RE: CHANGE TO APPLICATION AND APPLICANT RESPONSE TO INFORMATION REQUEST REFERENCED AS CA 2025_5880/1 (1363256)

Applicant Response to Information Request

We refer to the Information Request issued by Douglas Shire Council dated 5 May 2026 (Doc ID: 1363256) under Section 12 of the Development Assessment Rules in respect of the above-referenced development application. We thank Council Officers for their detailed review and constructive advice notes.

PLAN OF DEVELOPMENT - LAYOUT PLAN

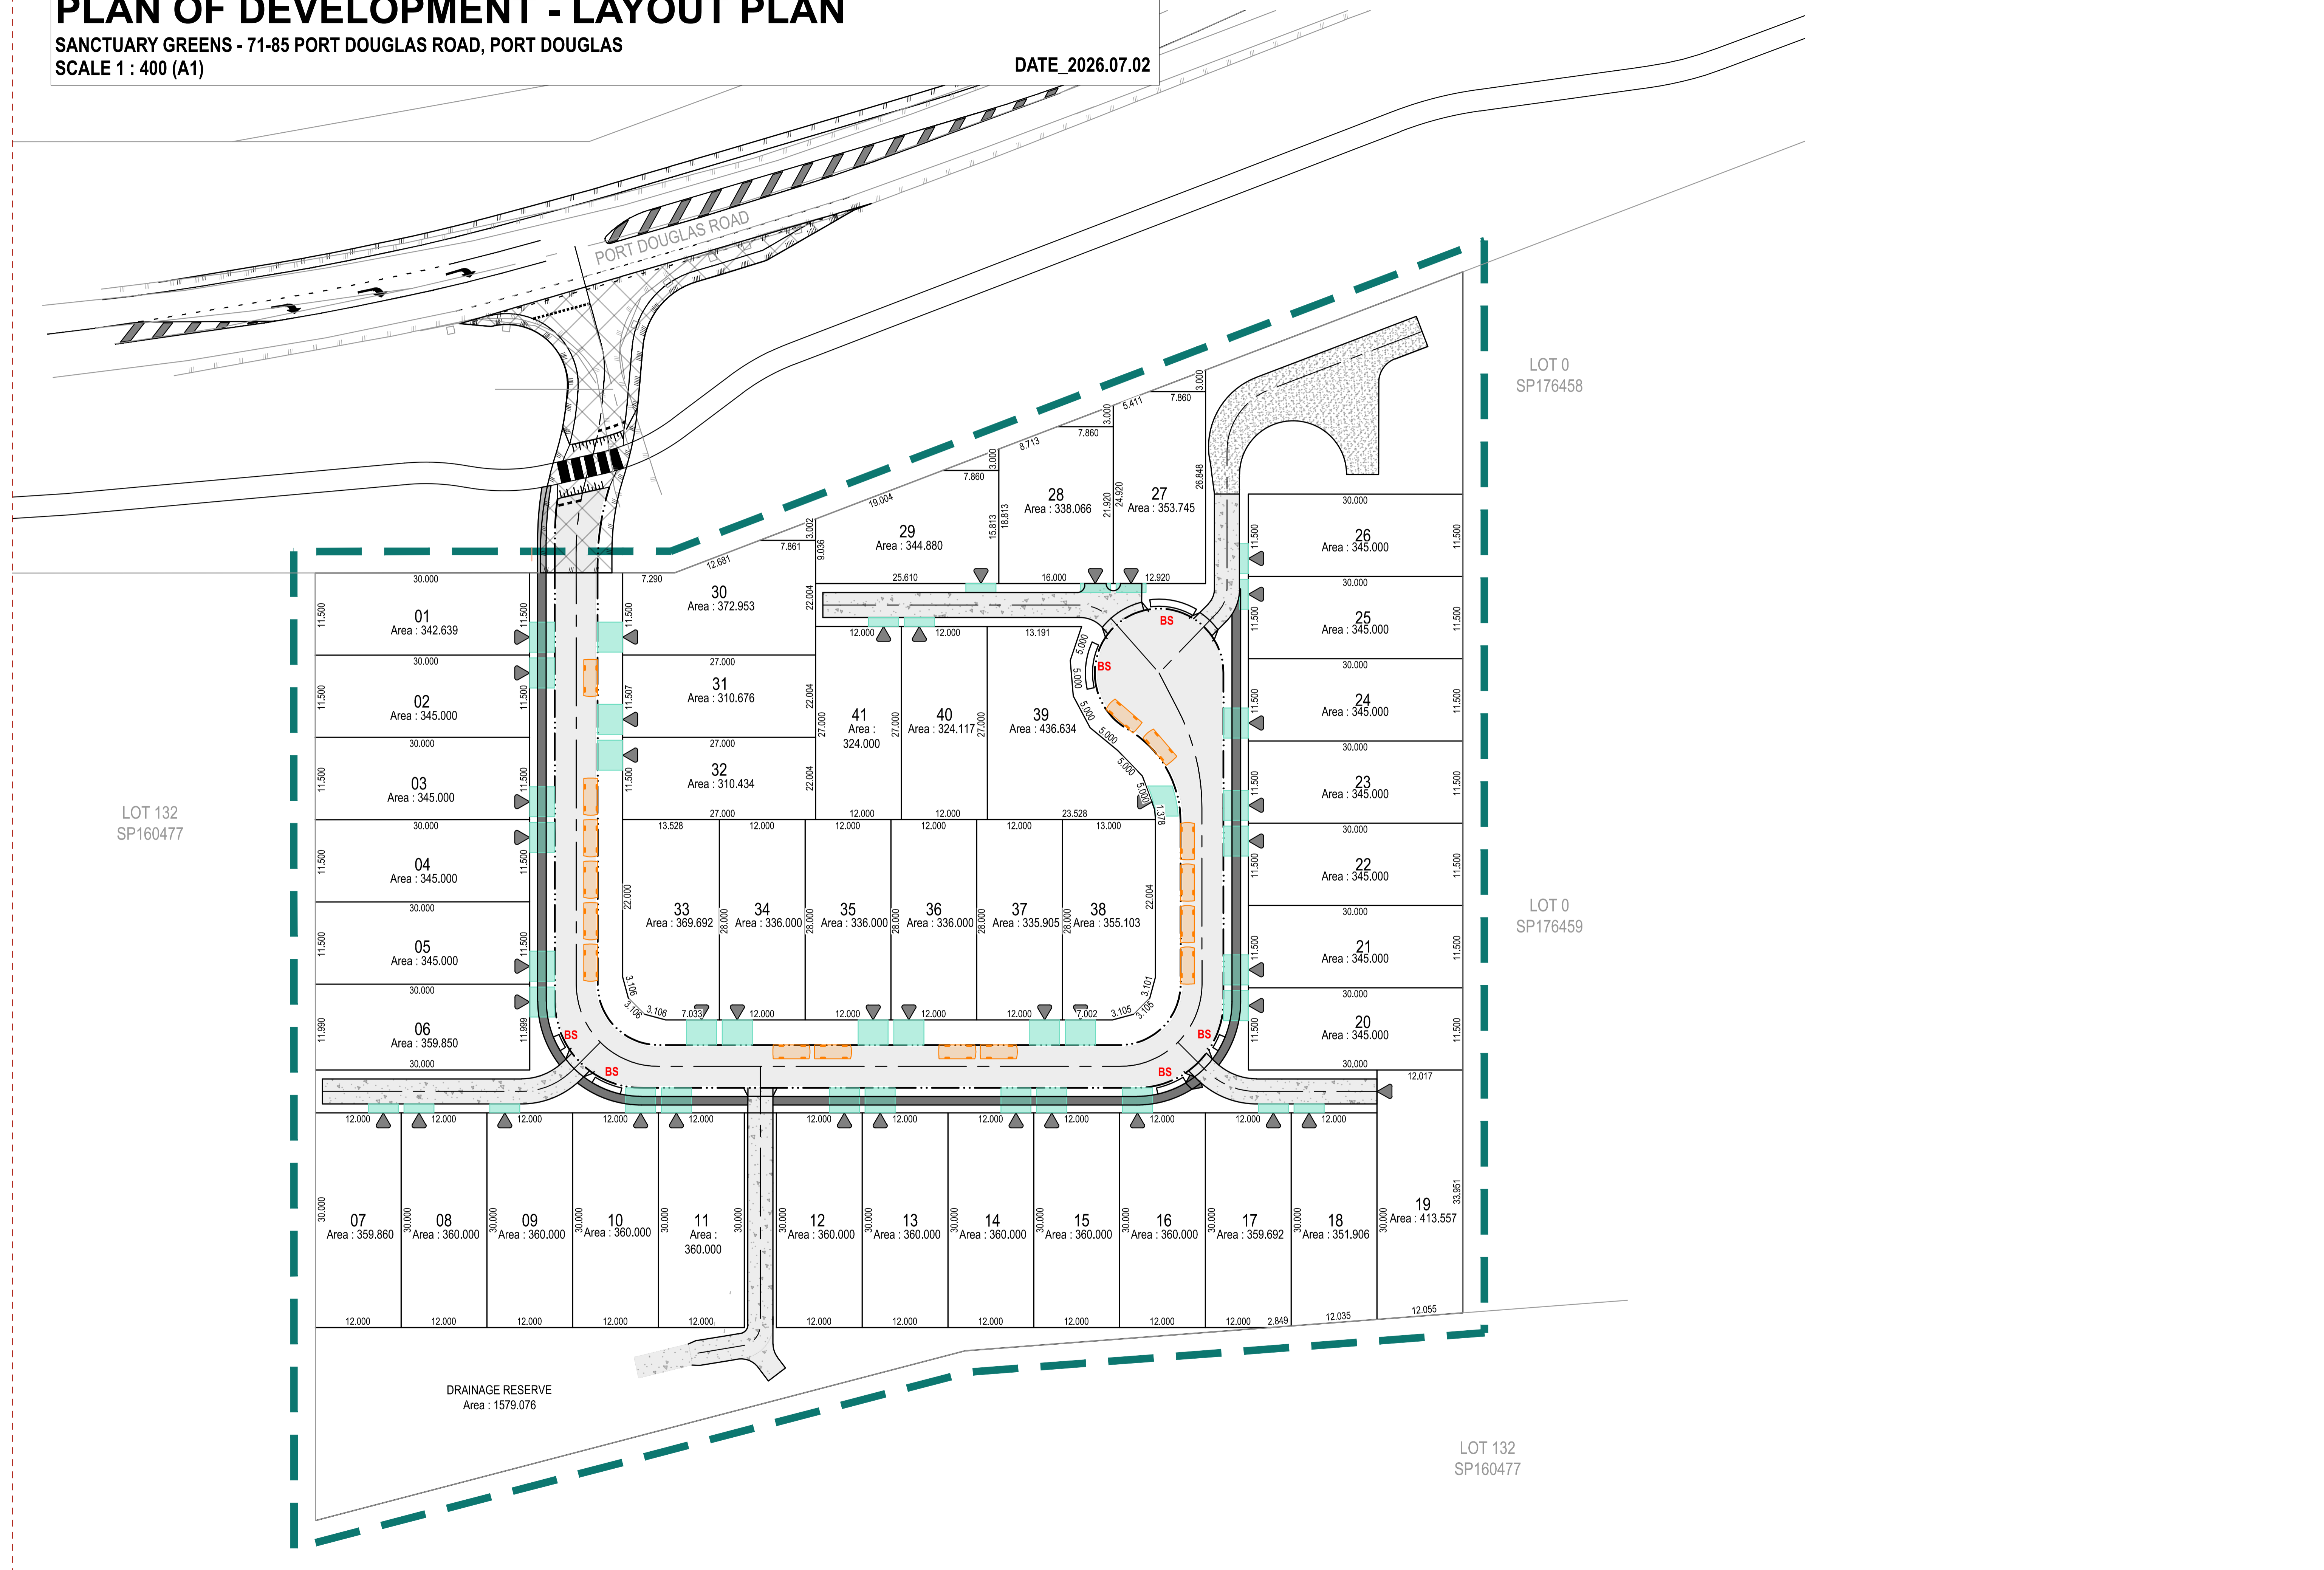
Item 16 – Updated Plan of Development – Kerbside Refuse Collection

The updated Plan of Development (**Attachment 1**) has been revised to include an appropriate refuse collection arrangement for all lots. All road-facing lots will be serviced by Council's standard Refuse Collection Vehicle (RCV) via kerbside collection of individual bins at each lot.

PLAN OF DEVELOPMENT - BUILDING ENVELOPE PLAN - 2

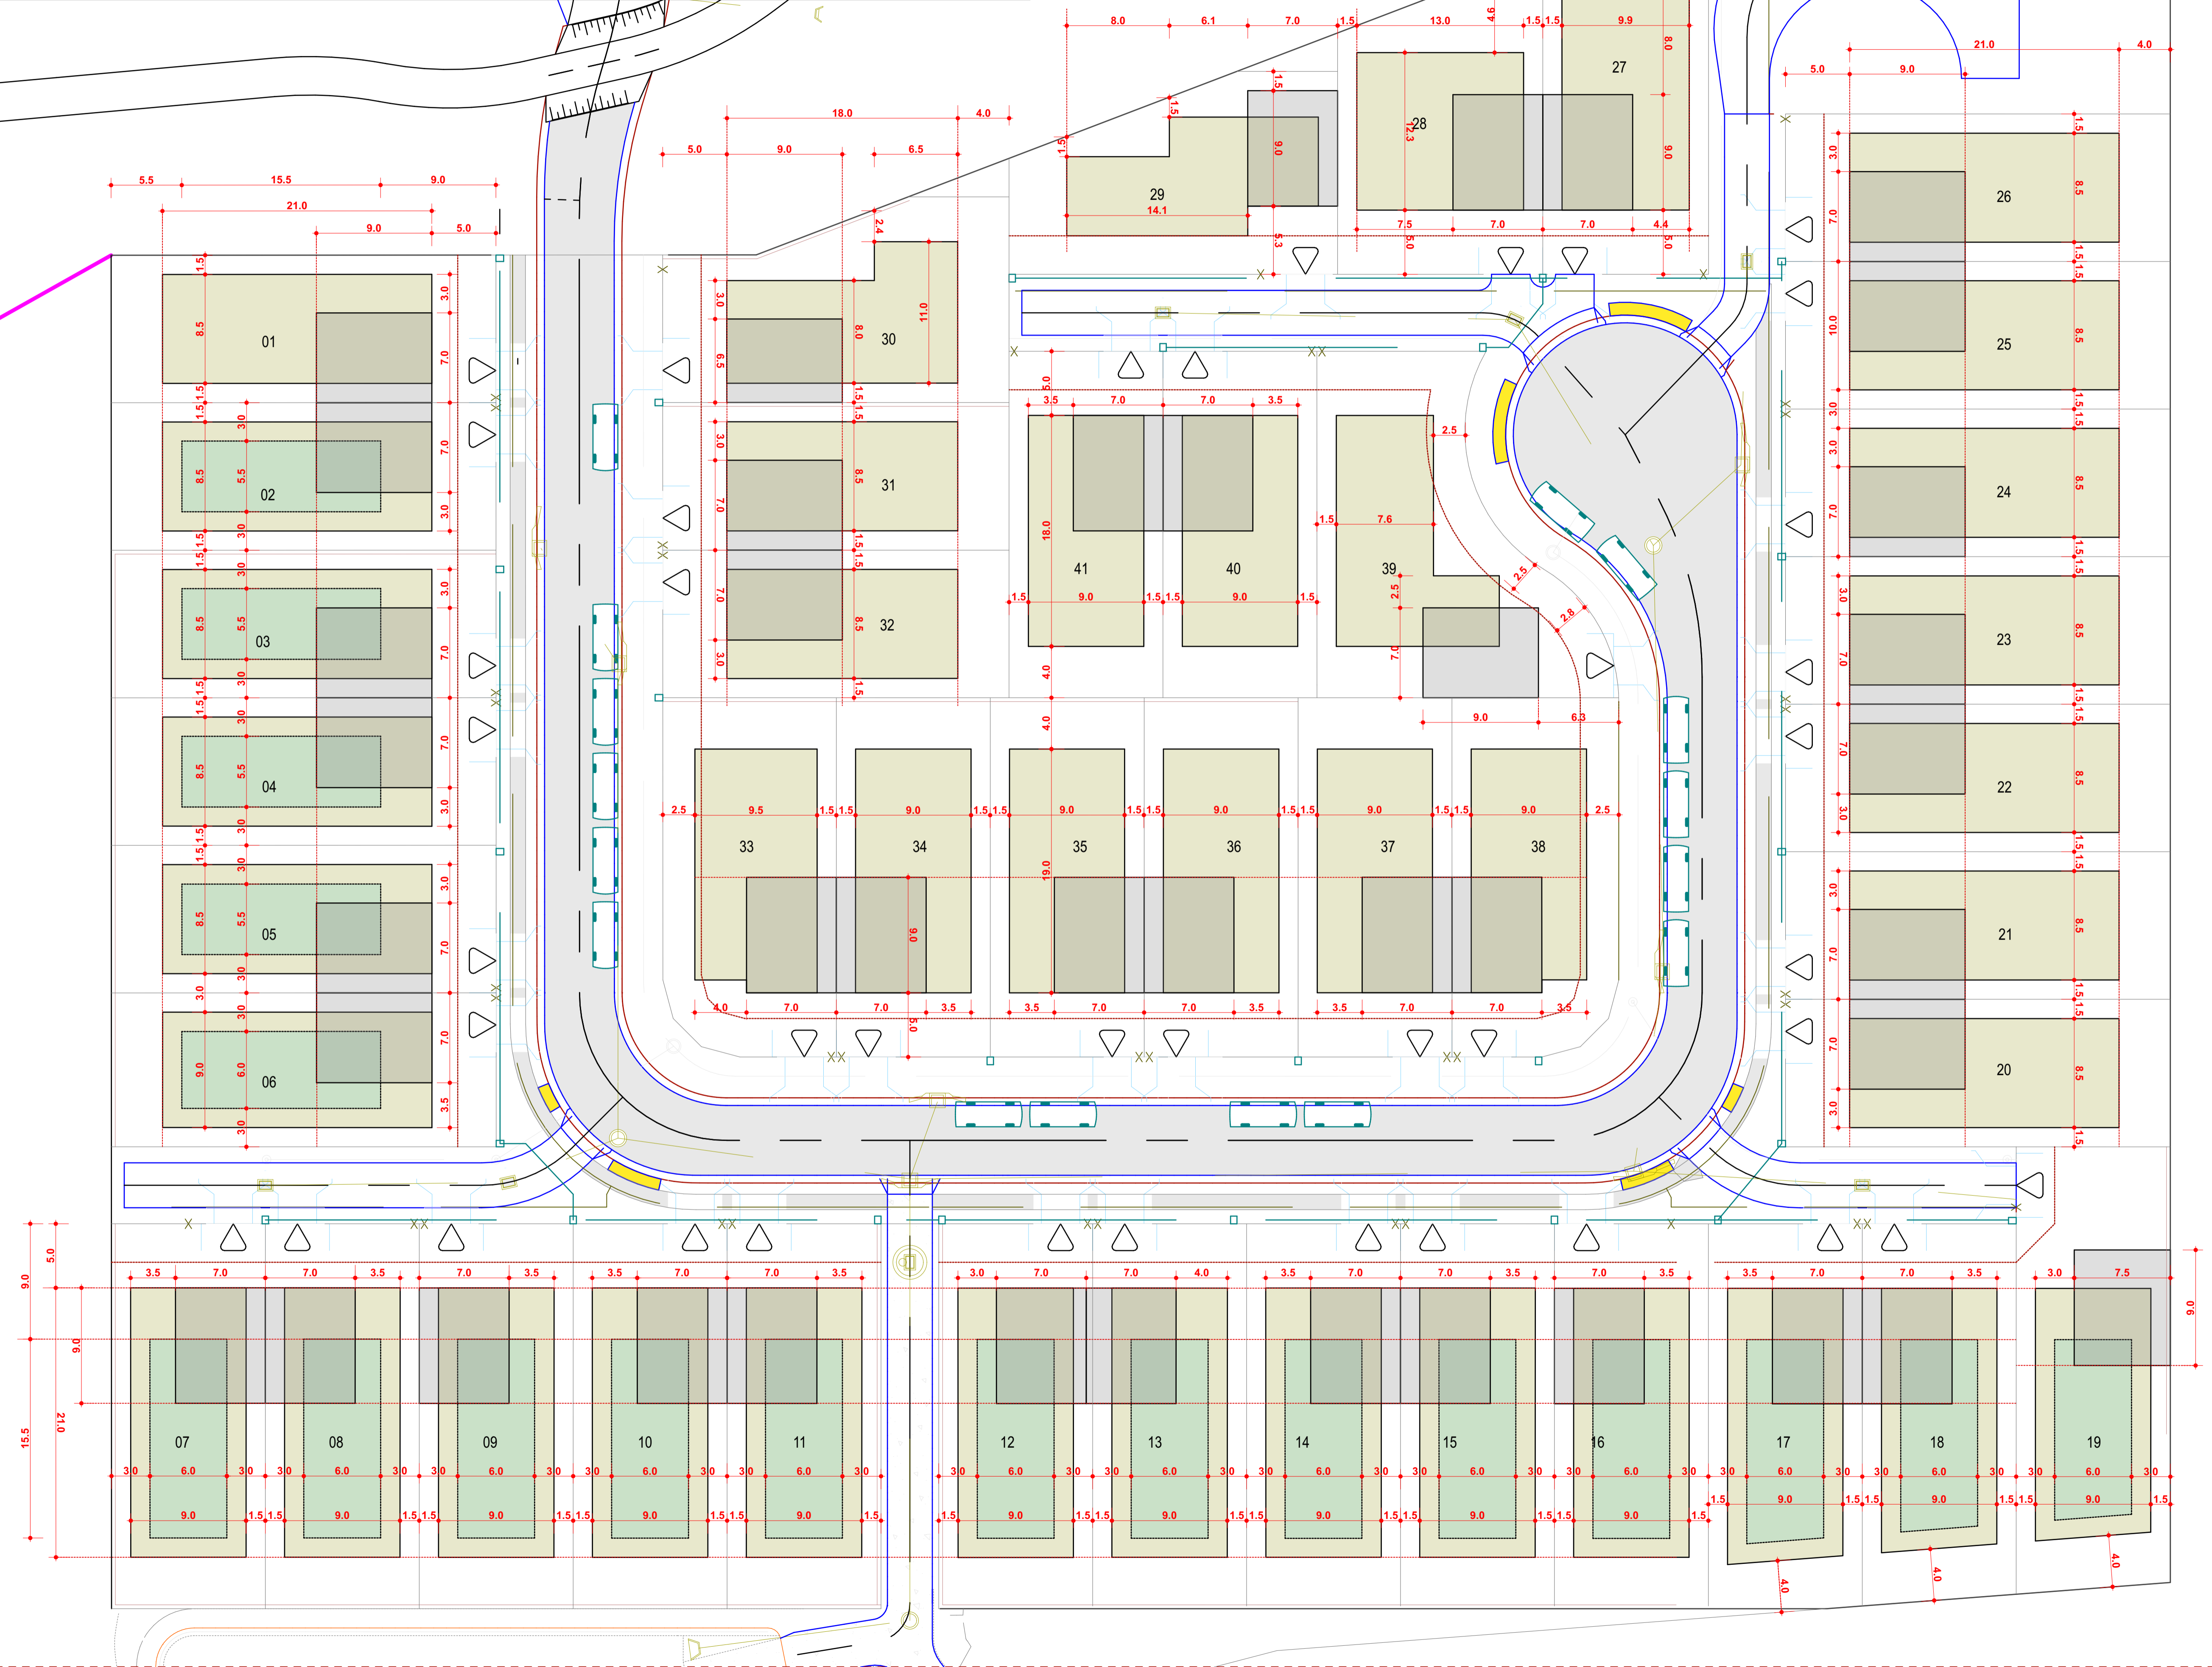
Item 3 – Updated Plan of Development – Minimum Lot Area (400 m²)

The applicant has reviewed the lot layout having regard to Council's advice. The submitted Plan of Development identifies lot areas ranging from 310 m² to larger irregular lots, with most regular lots having depths of approximately 27 m to 30 m and frontages generally in the order of 11.5 m to 12.5 m.

The Plan of Development now includes a Building Envelope Plan, enclosed as **Attachment 1**, which demonstrates that the proposed lot sizes are capable of accommodating the intended land uses with appropriate setbacks, site

Figure 5-1 Preliminary Water and Sewer Reticulation Layout Plan

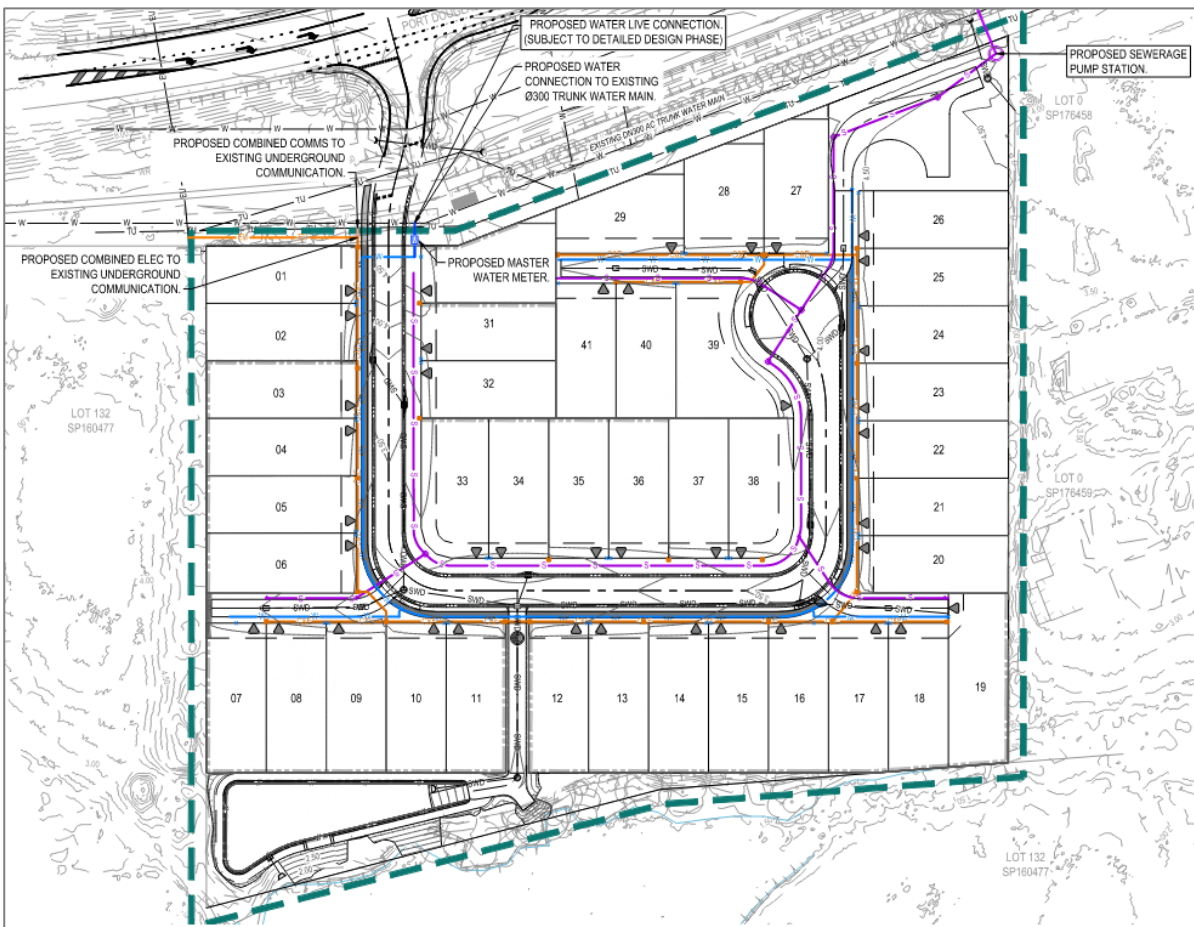
The site services layout plan is shown at Figure 5-1 of the Engineering Services Report at **Attachment 3**. As noted in the response to Item 23, the proposed development generates less EP than the LGIP planned demand for the site, and infrastructure charges have already been paid. It is therefore expected that the existing sewer network has sufficient capacity to service the development.
